January 9, 2017

Re: Review of Annual Maintenance  
977-ft Self-Support Tower  
San Francisco, California  
TCI Project Number 16.082.001

**Photo No. 3 (Before)**

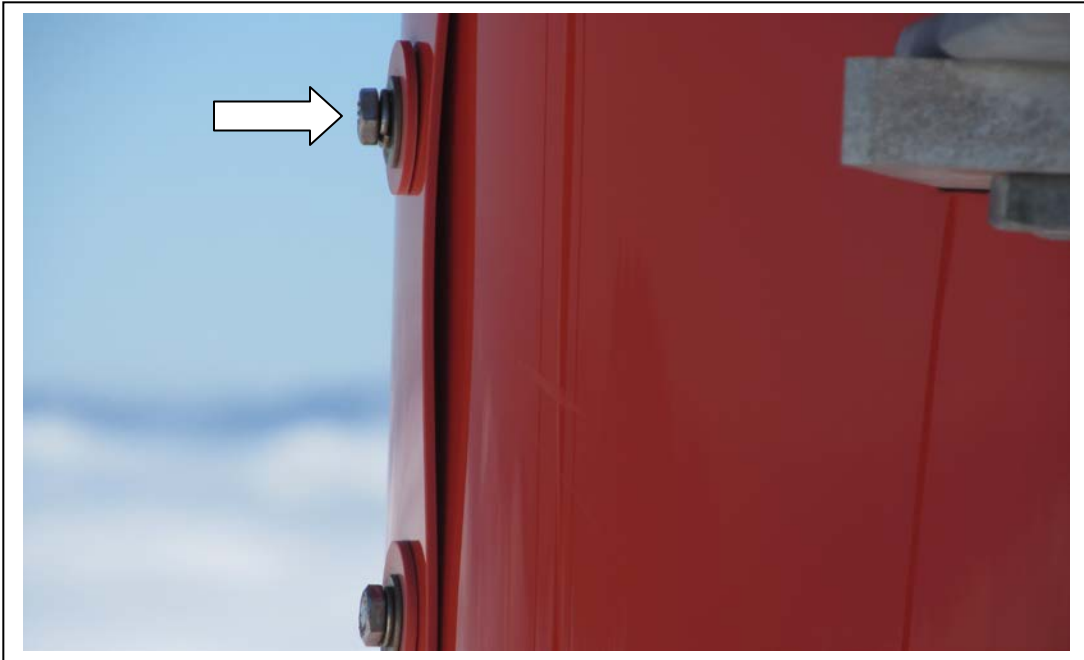
1. Address all issues found during the 2016 annual inspection at level 6 and stack C. All loose radome bolts for the side mounted TV antenna on stack C were properly tightened (Photo Nos. 3 and 4). A top skin support horizontal member on leg A was replaced with new stronger member (Photo Nos. 5 and 6).

Photo Nos. 3 and 4 show the side mounted TV antenna on stack C before and after radome bolt tightening.

**Photo No. 5 (Before)**

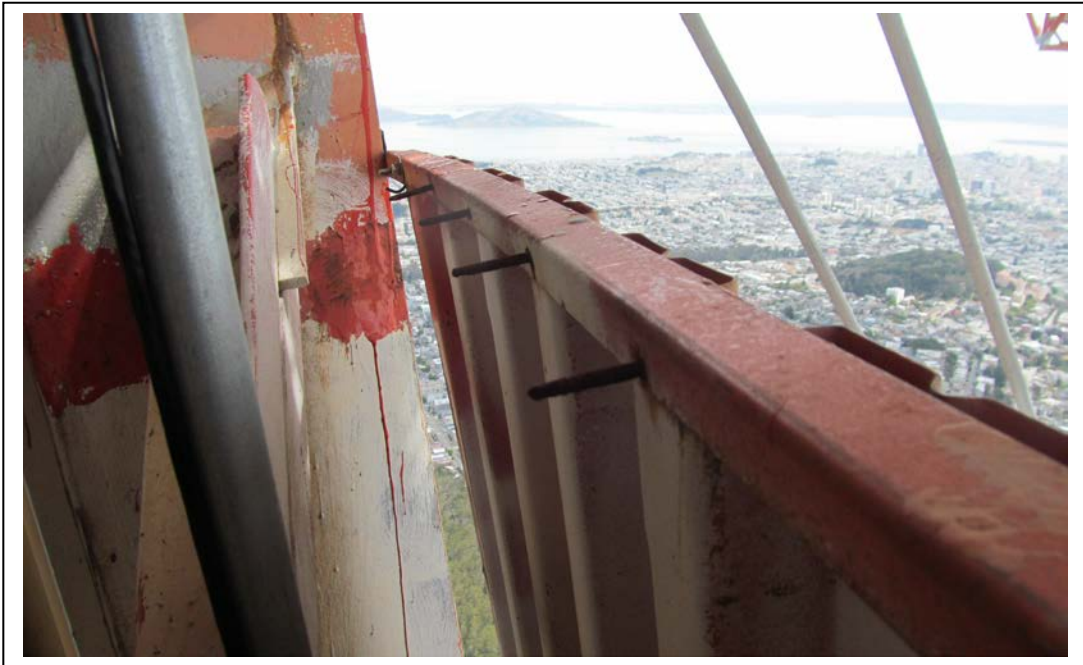
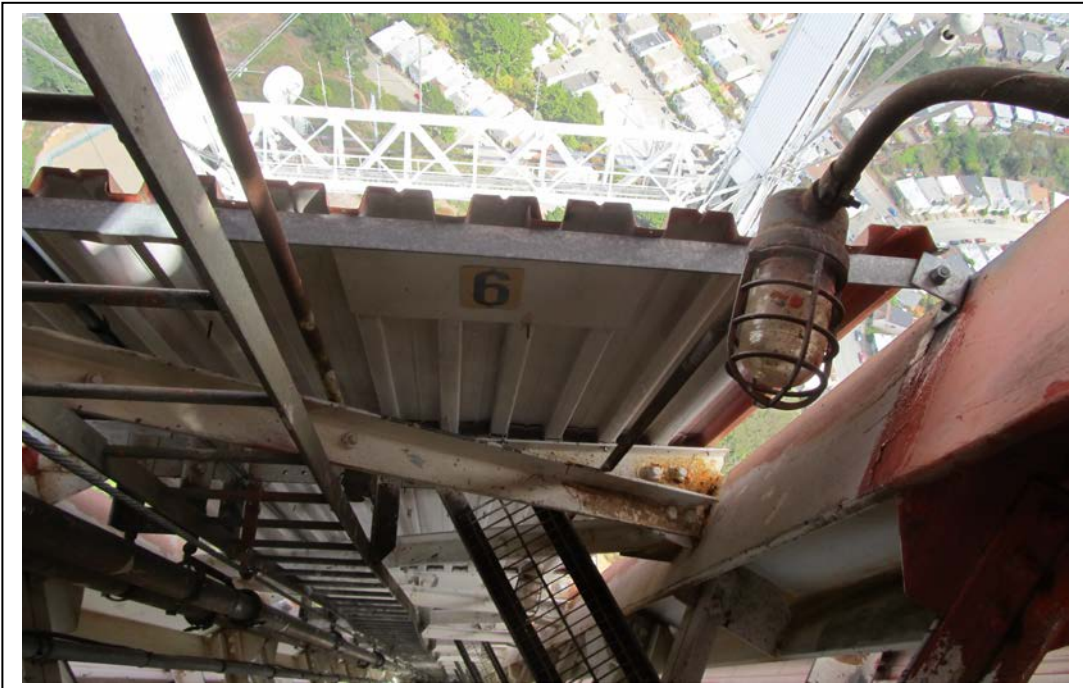
Photo Nos. 5 and 6 show the new skin support horizontal just below level 6 on leg A before and after angle replacement.

**Photo No. 14 (After)**

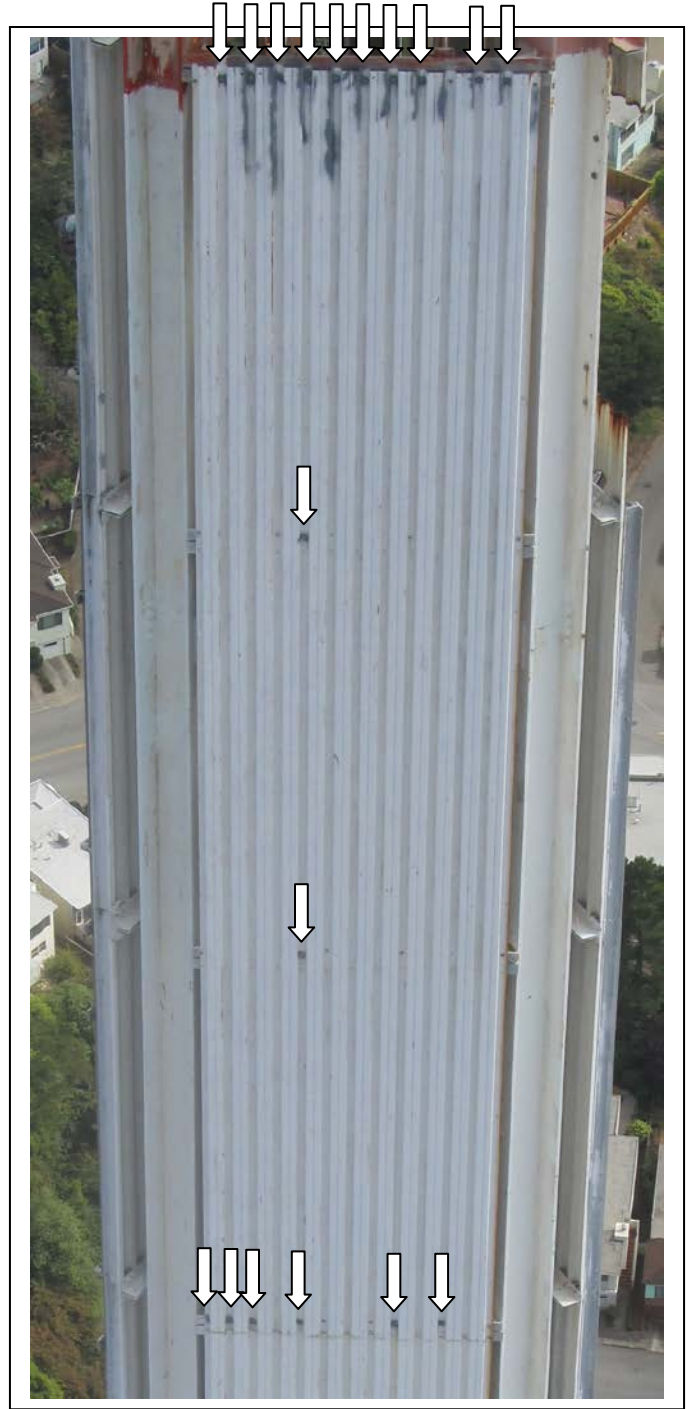
Photo Nos. 13 and 14 show the skin panels before and after panel reinforcing by adding more connection bolts. The arrows show the locations of the new connection bolts.

**Photo No. 17 (After)**

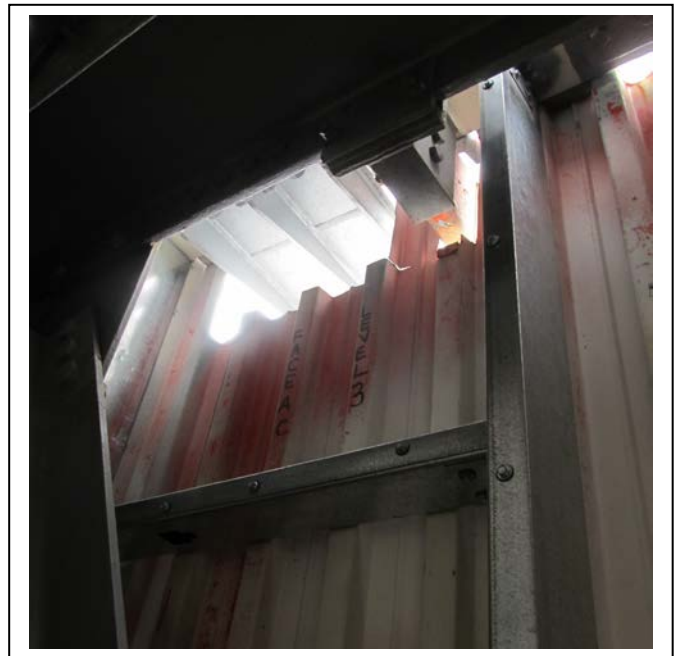
Photo Nos. 15 - 17 show the skin panel reinforcing at various levels after the recent repair work.
